**Village of Paw Paw
Planning Commission Regular Meeting
Thursday, September 5, 2024**

To: Village of Paw Paw Planning Commission
Date: August 30, 2024
From: Tricia Anderson, AICP
RE: **Site Plan Review – Walmart Parking Lot Modification and Building Expansion
1013 S. Kalamazoo St.**

Background and Request. Kaveh Ipakchian, of CESCO, on behalf of Walmart, has submitted an application for site plan review for some parking lot modifications and a small building expansion for Walmart, located at 1013 S. Kalamazoo Street (PPN: 80-600-013-15). The proposed modifications to the parking lot and building entrance would allow more efficient and convenient pick-up of online shopping orders. The subject parcel is comprised of 19.53 acres and is located within the B-2, General Business zoning district. The new online order pick-up spaces are planned within the existing parking lot in the southeast corner of the parking lot on the west side of the building.

PROJECT NUMBER: 763517
SCALE: AS SHOWN
DRAWN BY: MDR
CHECKED BY: MST
DATE: 06.25.2024
ISSUE: NOT FOR CONSTRUCTION
SHEET: CONCEPT
C-1

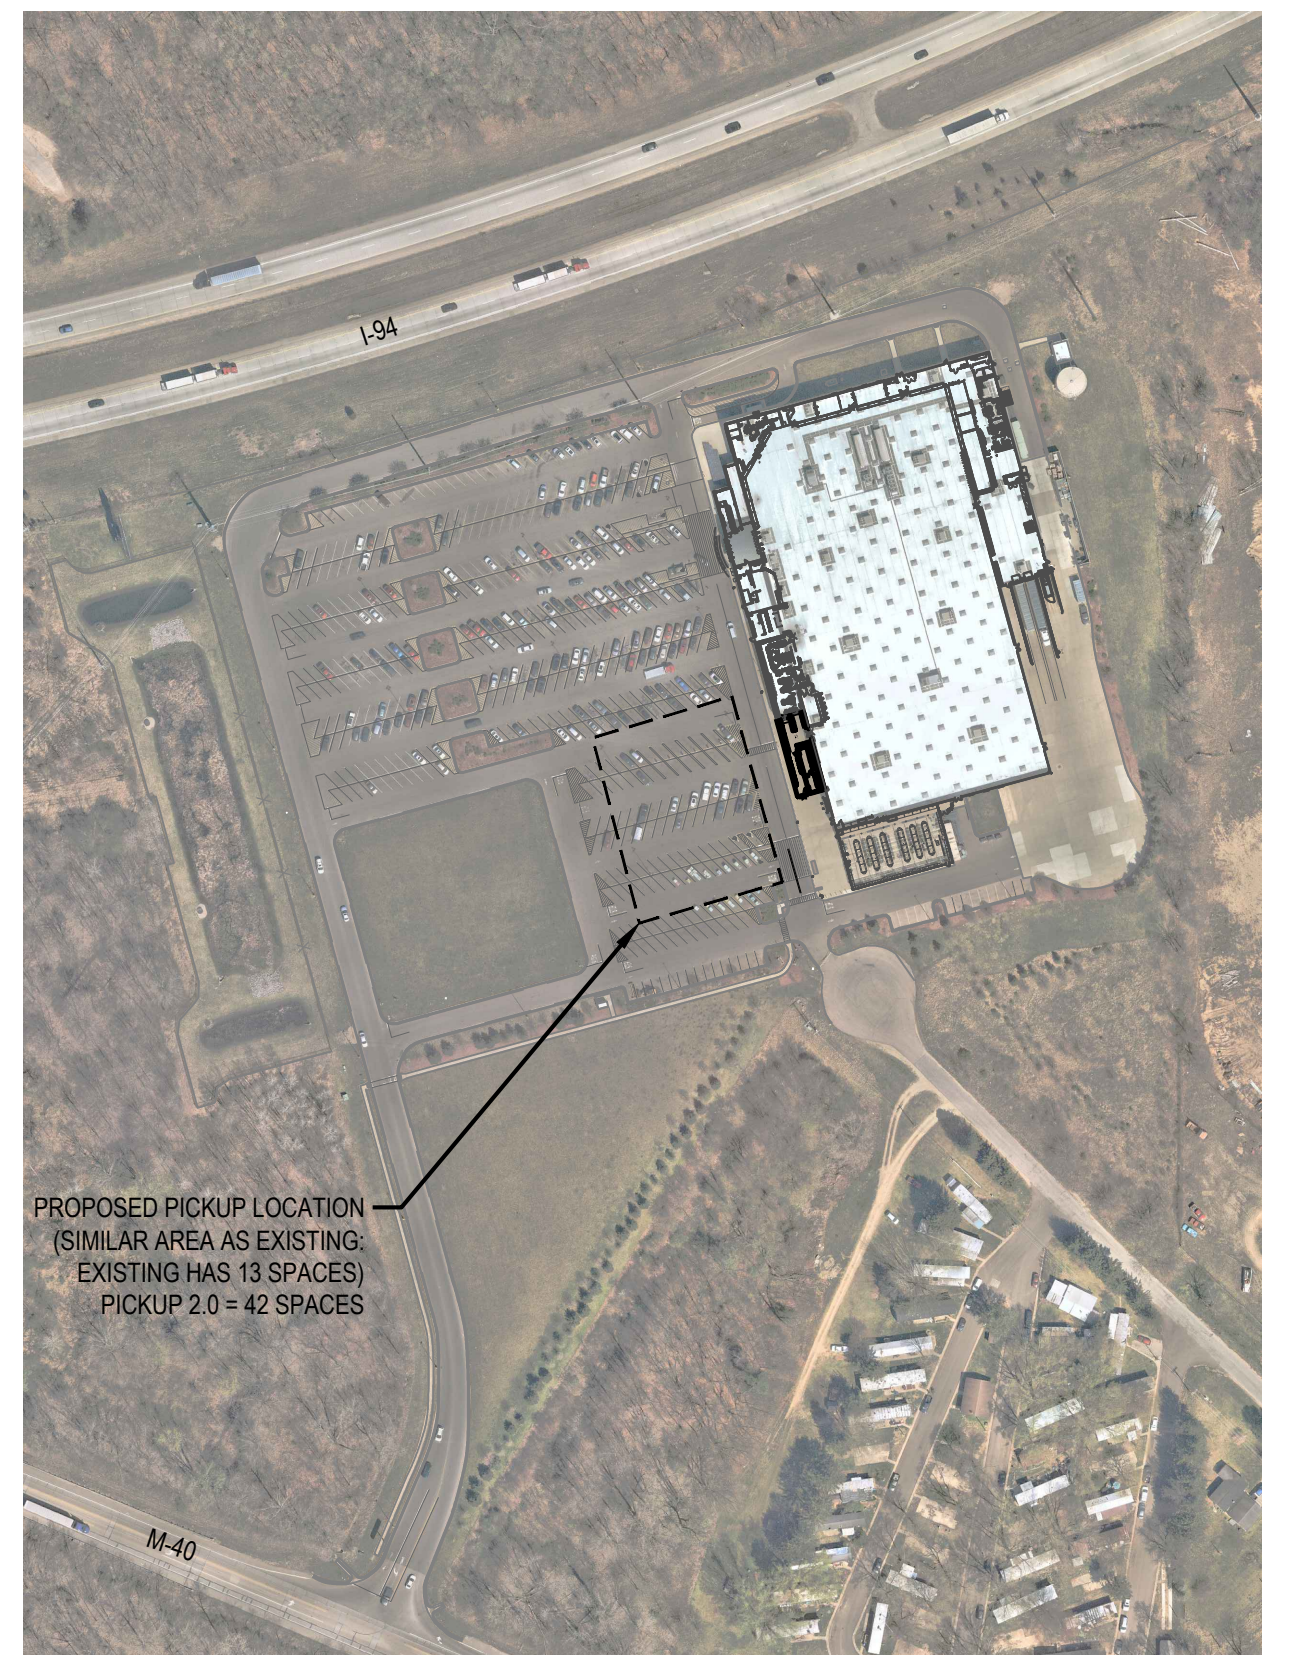
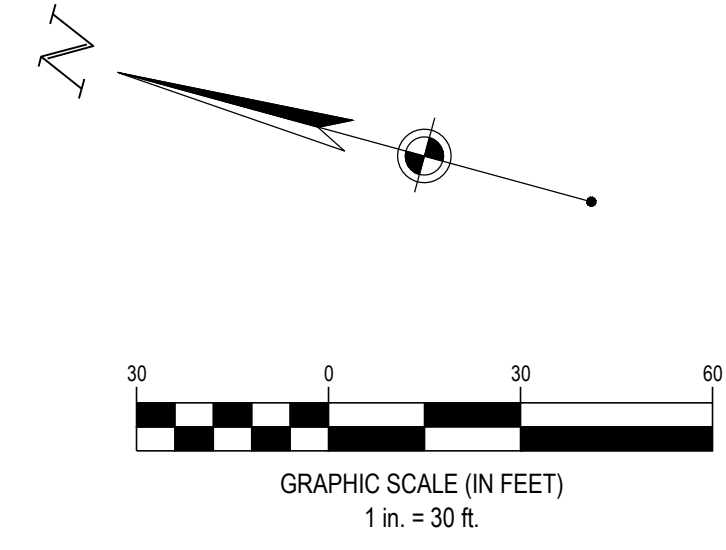
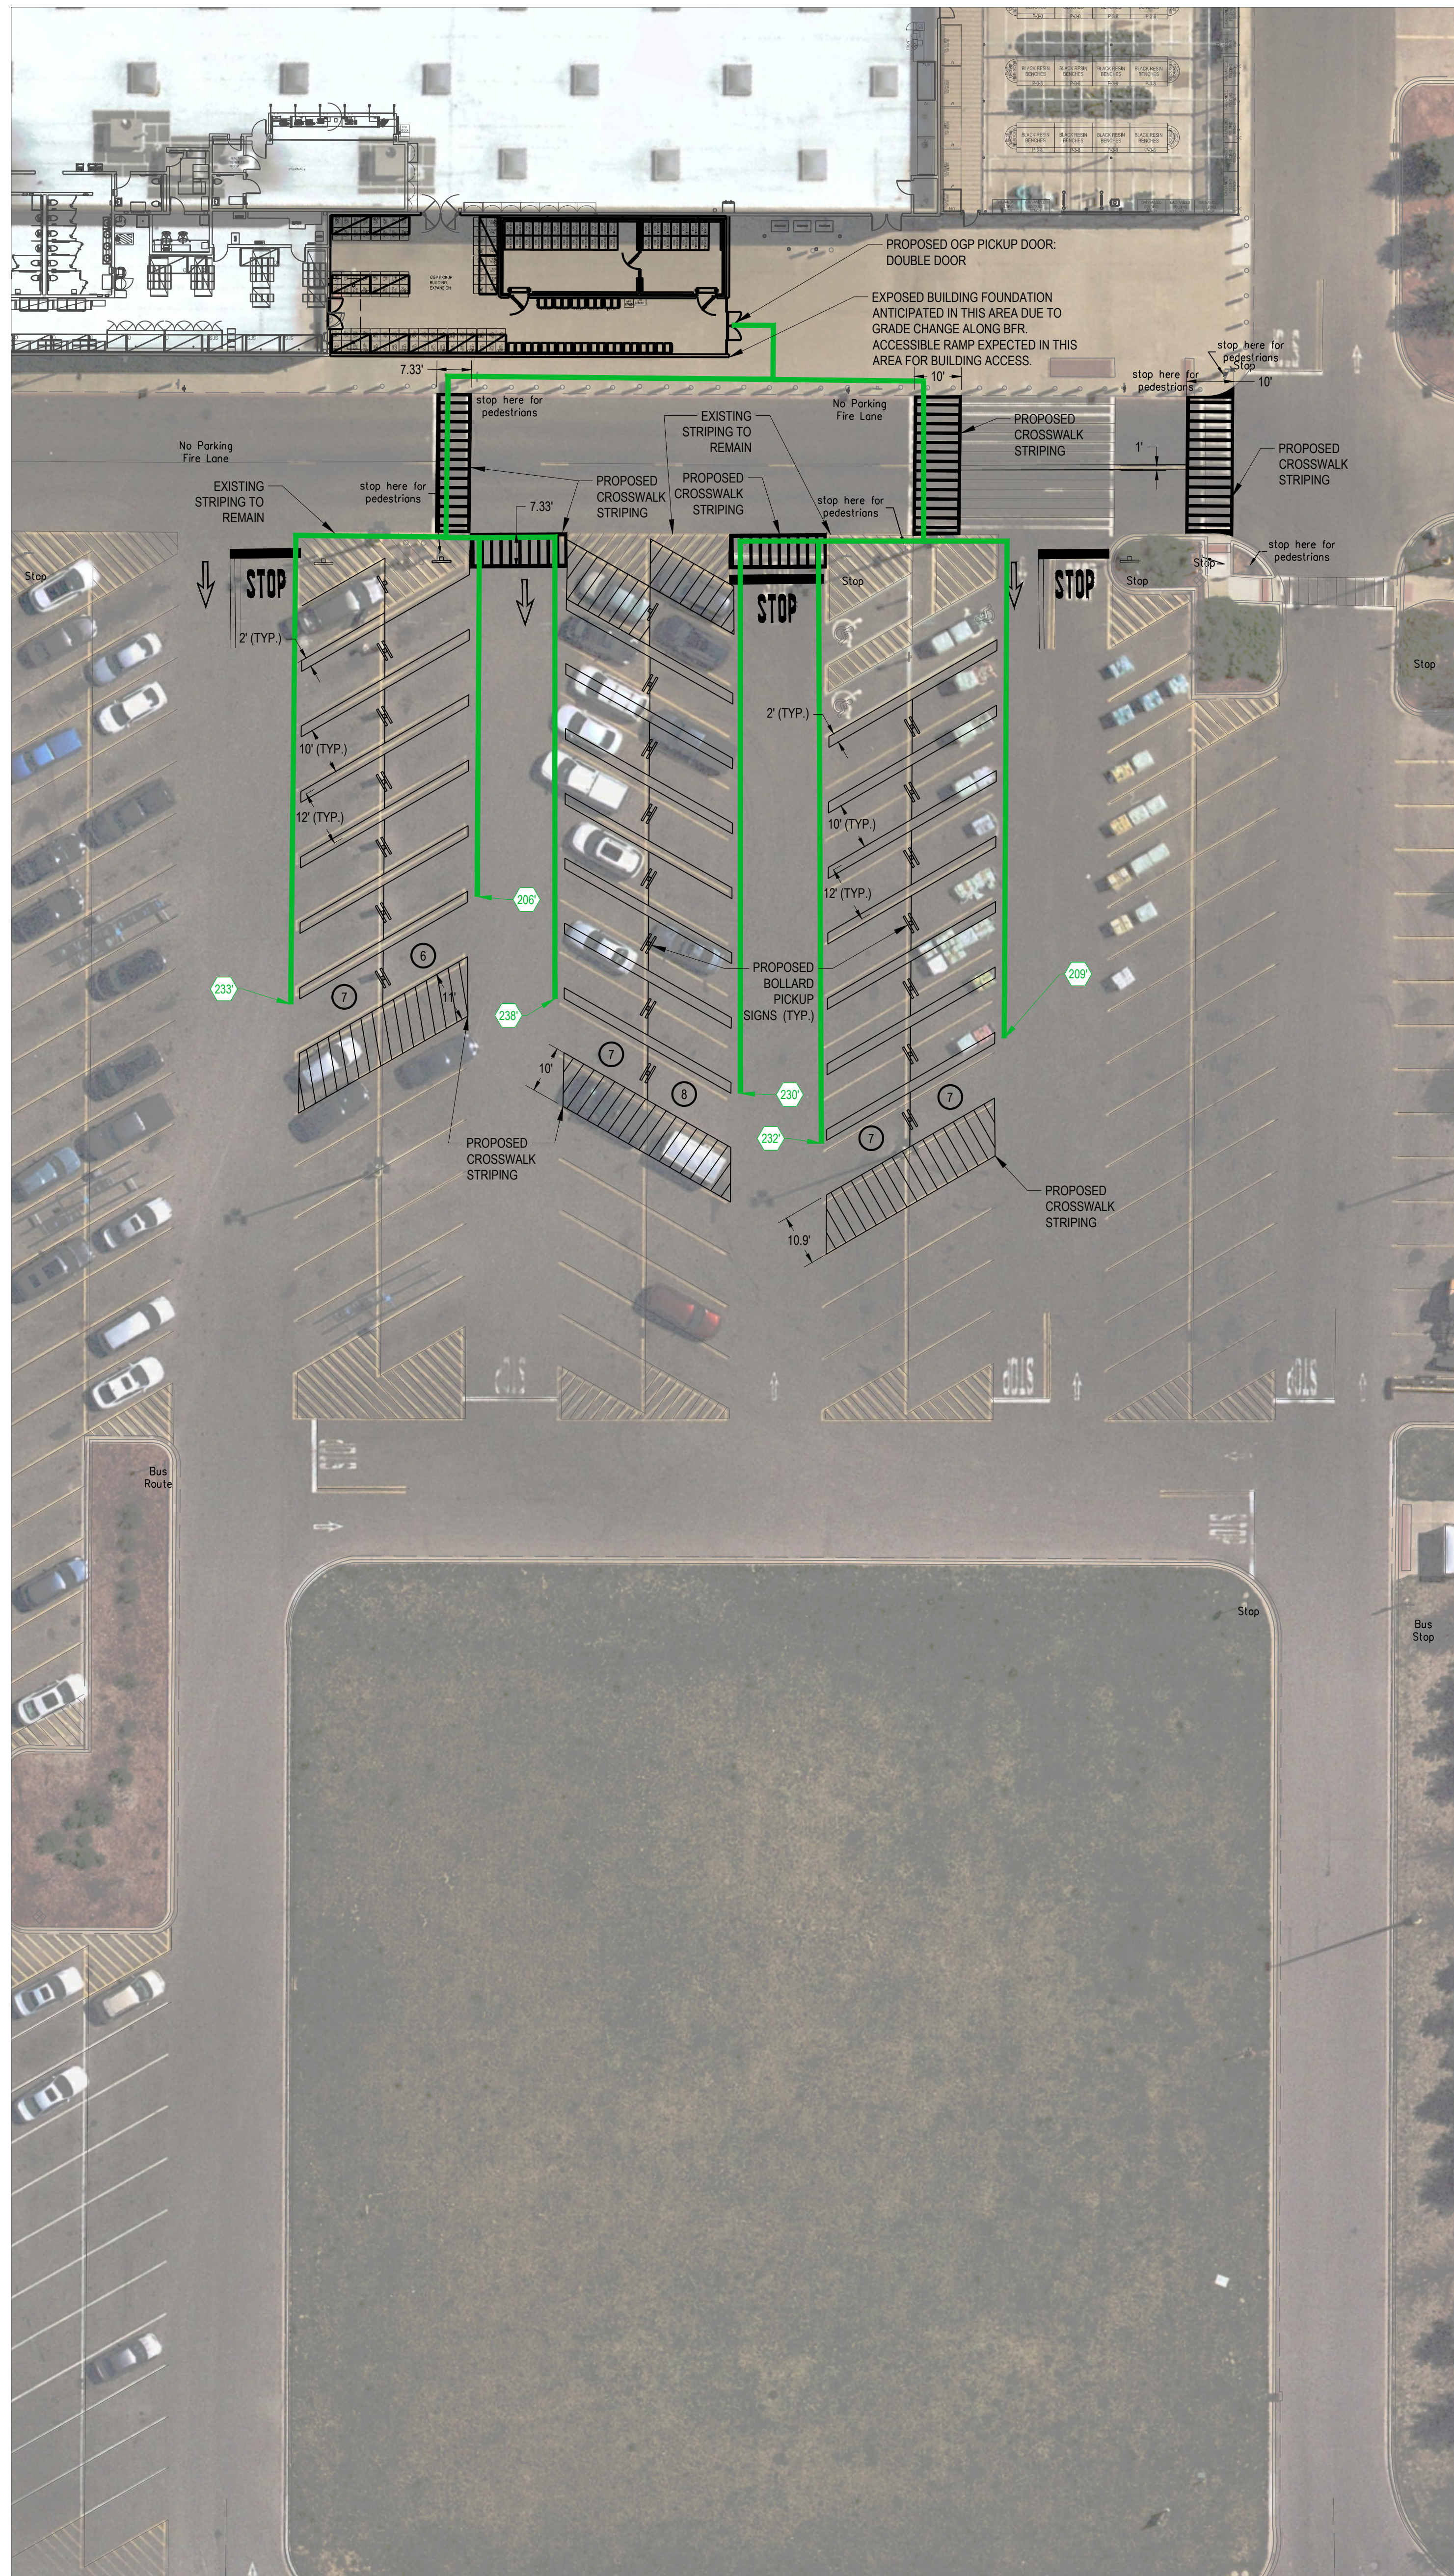
1. Building dimensions – the proposed expansion is minor, however, we are unable to locate dimensions or an area measurement for the proposed expansion.
2. Drive aisle and parking space depth dimensions are not provided on the plan.
3. Building elevation renderings for the proposed building expansion have not been provided.

Remarks: The drive aisles are shown on the plan, however, to ensure that efficient vehicle movements will be maintained on the site, the dimensions must be shown to ensure that they meet Section 42-404 (see Figure 4).

5. The applicant shall apply for sign permits for all proposed signage, as applicable.
6. The applicant shall submit a revised site plan that contains the missing dimensional information (drive aisle widths, parking space depths, bulding expansion dimensions and area) that complies with Section 42-404 of the Zoning Ordinance, for review and approval by the Zoning Administrator, prior to the issuance of zoning or building permits associated with the proposed improvements.
